- ✓ **Technical Service Bulletin**
- ✓ **Product Update/Supersession**
- ✓ **Service Procedure**

Subject: Internal Identifier Update
Affected Models: FX3030, MFX3030 and W050400103 with firmware less than v2.17

Campaign 2016-06-09

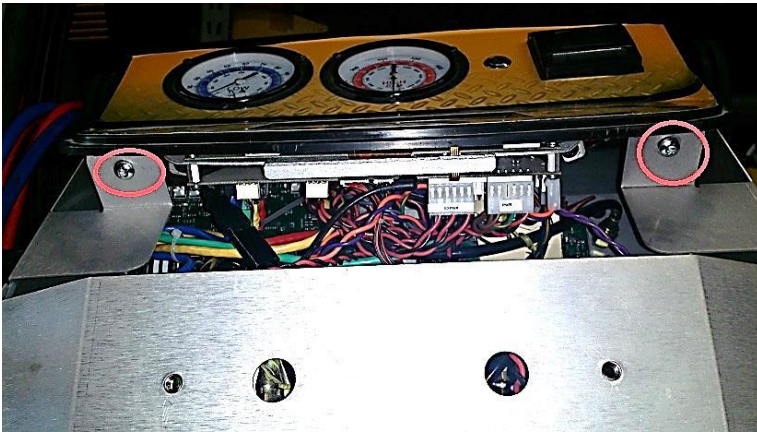
- 1) Remove 4 black Phillips screws from the top of the unit

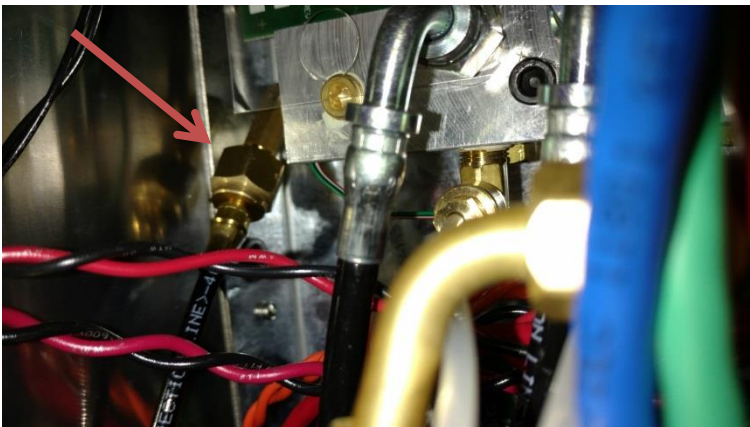
- 7) Remove the 2 T30 fasteners from the control panel.

- 8) Transfer black hose to the distillation chamber (Top right—remove cap to place Black Hose)
9) Cap off the port with the cap from the DOA chamber

- 10) Replace the restrictor/filter assembly; replace the external clear filter (discard old parts) and install identifier.
11) Replace all panels in the reverse order.
